Agenda
Village of Arlington Heights
Design Commission
Community Room, 3rd floor

Arlington Heights Village Hall
33 S. Arlington Heights Road
Arlington Heights, IL 60005
February 12, 2019
6:30 PM

A. DC#18-066 - 1518 W. Thomas St. - SF/Teardown

A. DC#18-104 - Arlington Block 425
44 S. Highland Ave/225 W. Campbell St/33 S. Chestnut Ave.
CBD Mixed-Use

ARLINGTON 425: 225 W. CAMPBELL NORTH ELEVATION

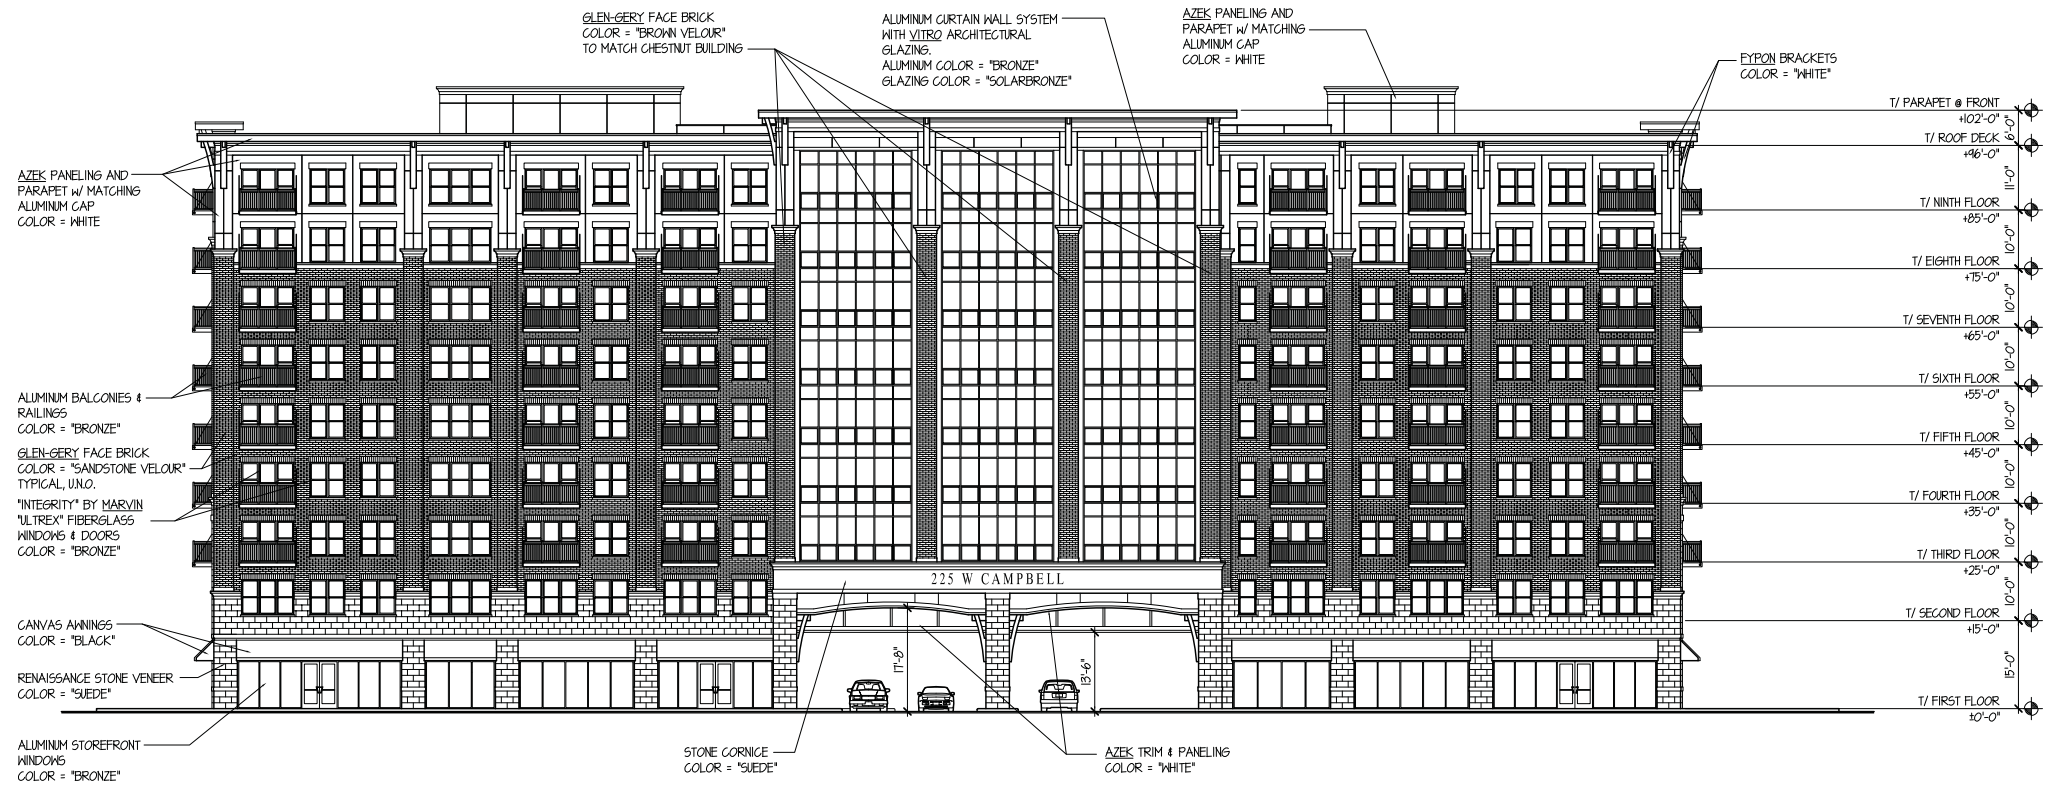
- The character of the first floor retail is well defined from the upper façade, and includes wall space for future retail signage.
 - The only comment on the design is to clarify the color of the stone trim pieces, which are illustrated as white in the renderings, but are not labeled on the architectural elevations. The raised stone bay on the east & west ends has a thick white cap that appears oversized. It is recommended that this detail be revised to match the stone cap at the drive-through bay on the north elevation.

ARLINGTON 425: 225 W. CAMPBELL EAST ELEVATION

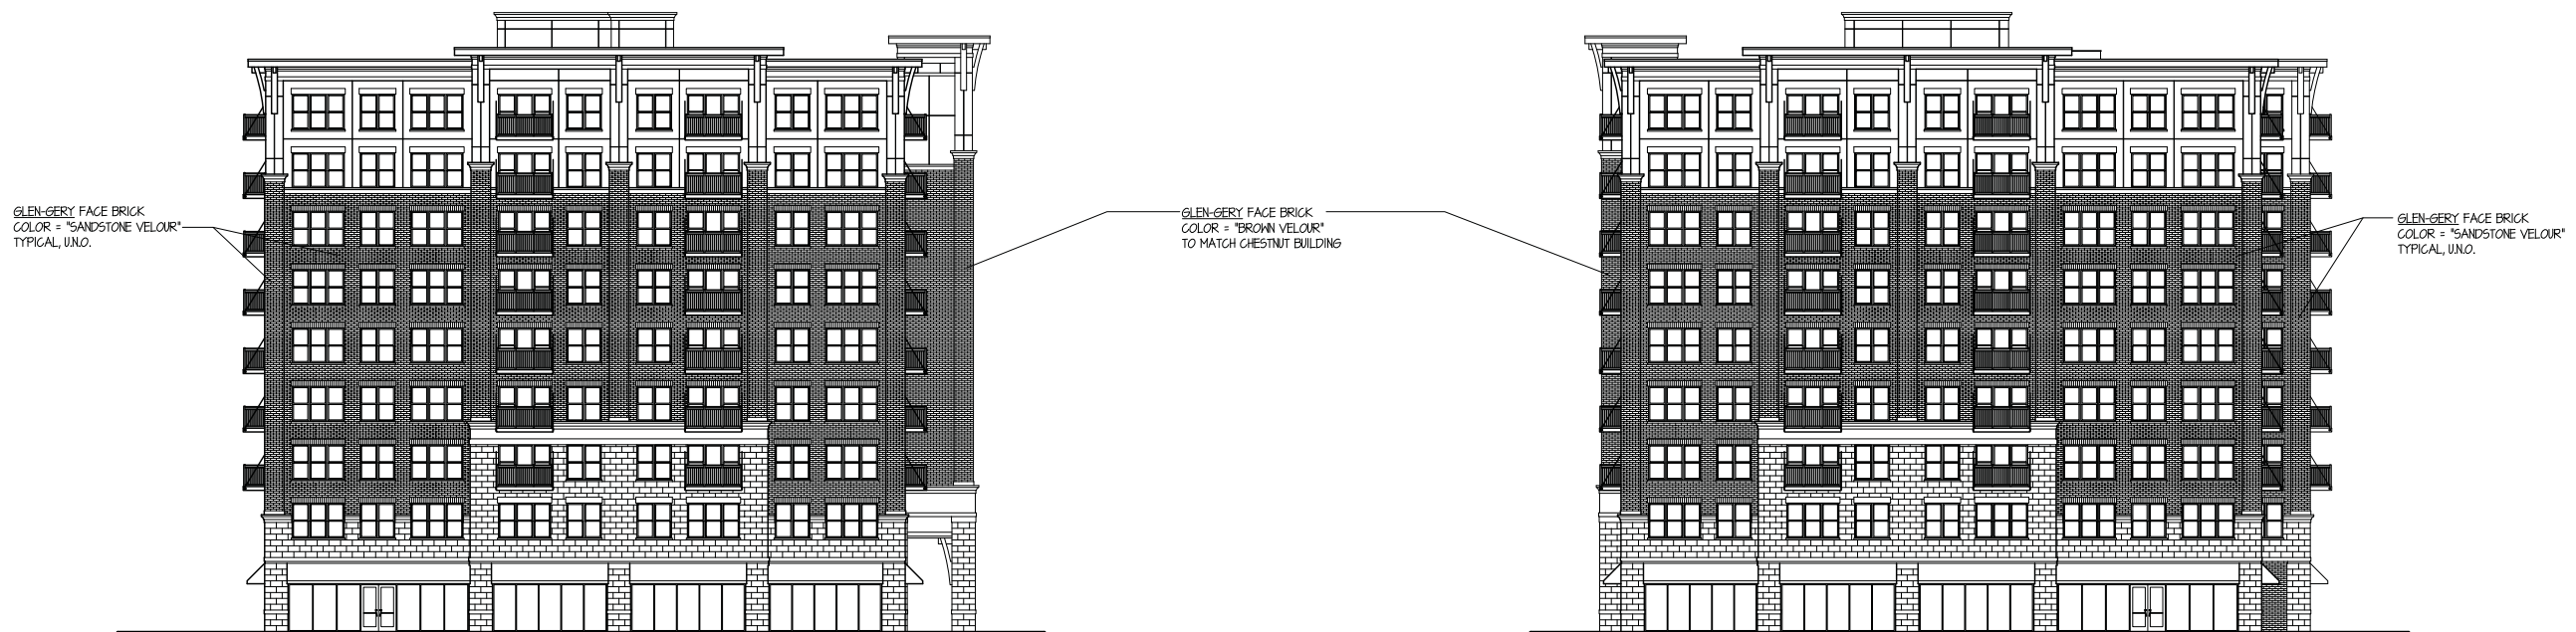
1. Campbell Street building. Clarify the color of the stone trim pieces. The raised stone bay on the east & west ends has a thick white cap that appears oversized, and it is recommended that this detail be revised to match the stone cap at the drive-through bay on the north elevation.

ARLINGTON 425: 44 S. HIGHLAND EAST ELEVATION

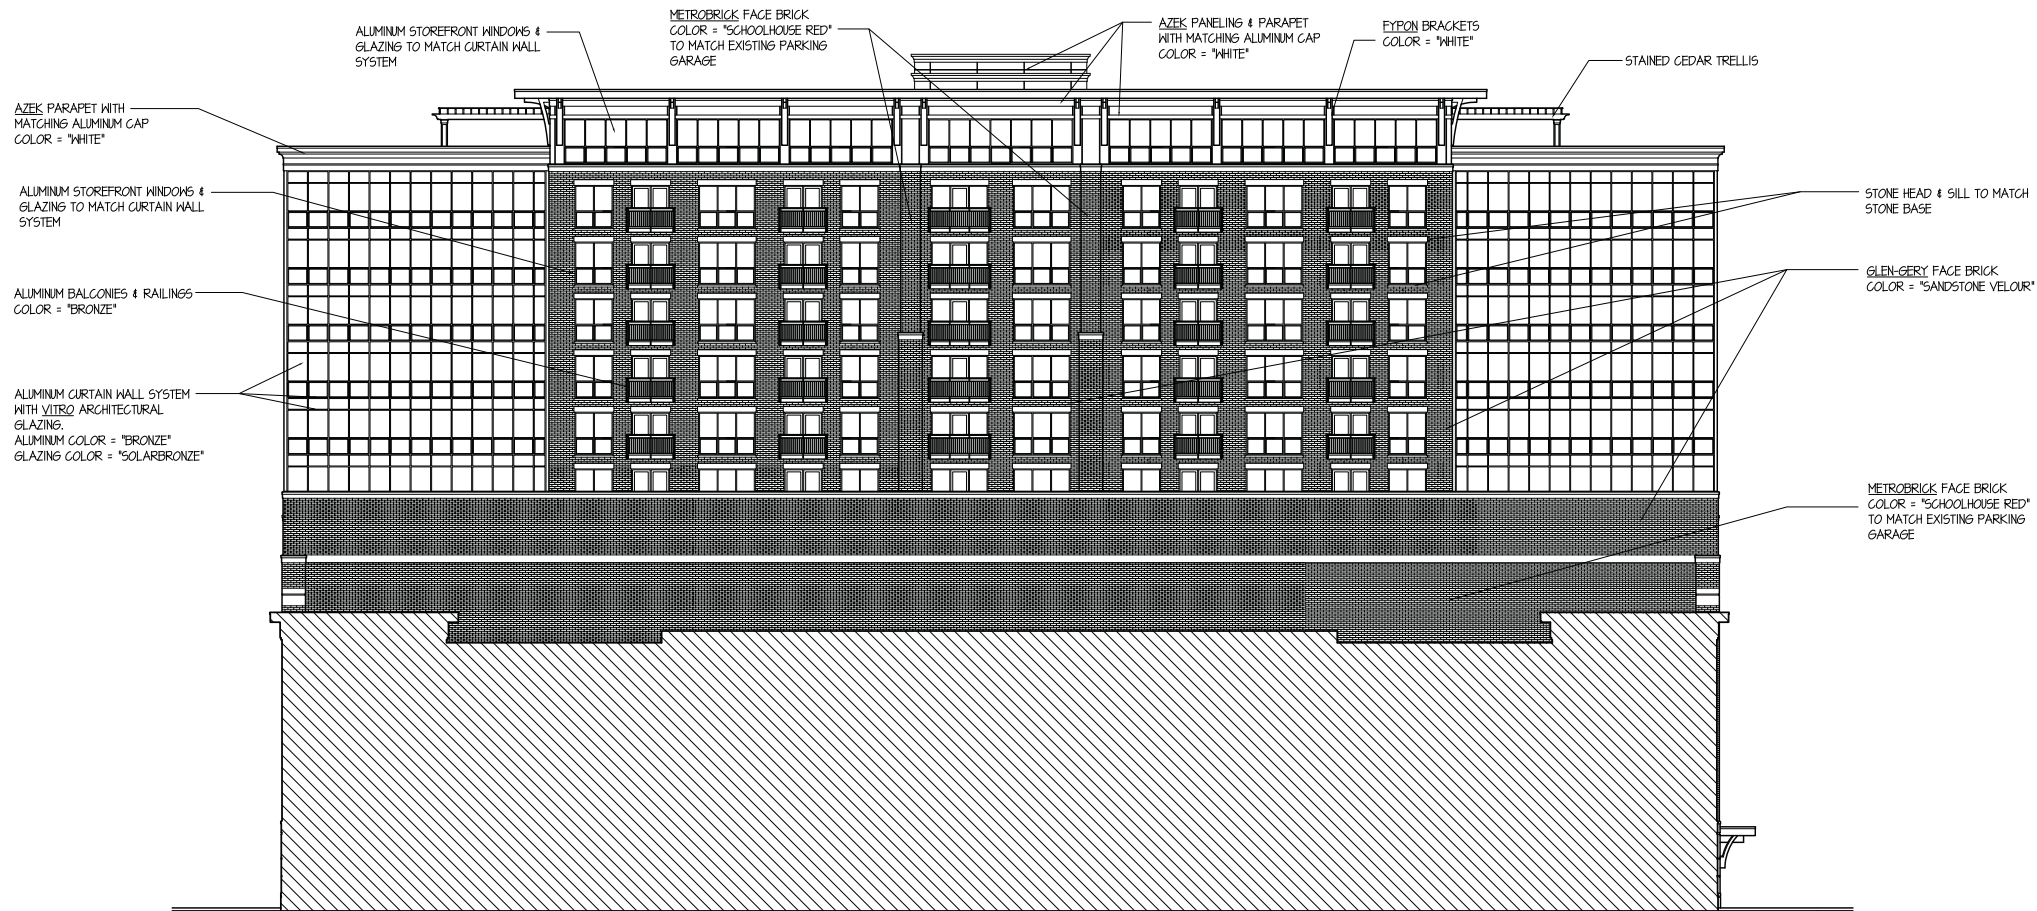
4. Highland Avenue building. It is recommended that a curved curtain wall bay window be added to the east elevation, to match the west elevation.
5. Highland Avenue building. It is recommended that wall openings be added to the first floor of the south wall to break up the large blank wall area. However, consideration should be given to vehicle headlights circulating inside the garage.

ARLINGTON 425: 44 S. HIGHLAND SOUTH ELEVATION

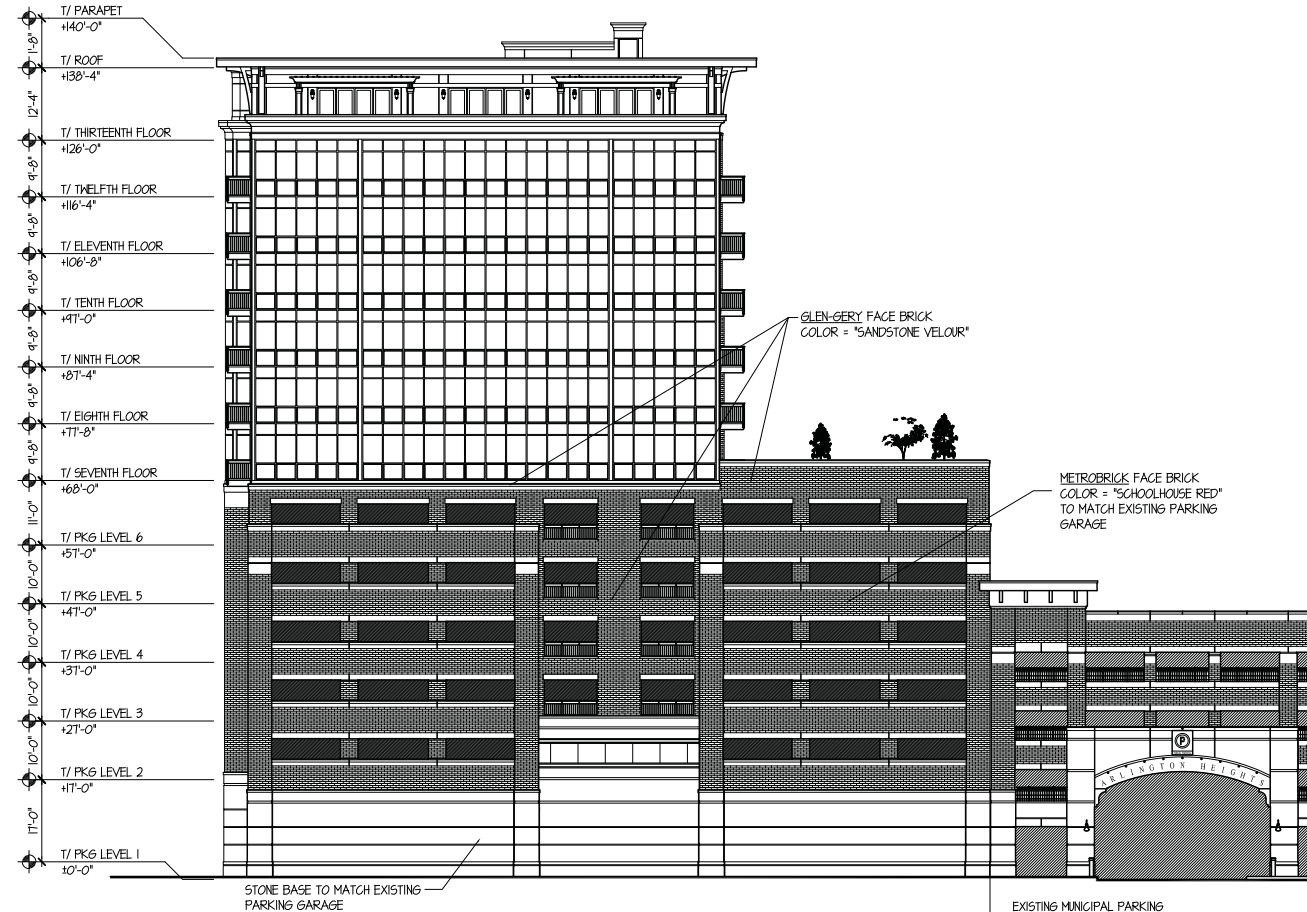
- The first floor of the south wall is large and blank. It is recommended that openings be added to break up the large wall area. However, consideration should be given to vehicle headlights circulating inside the garage.
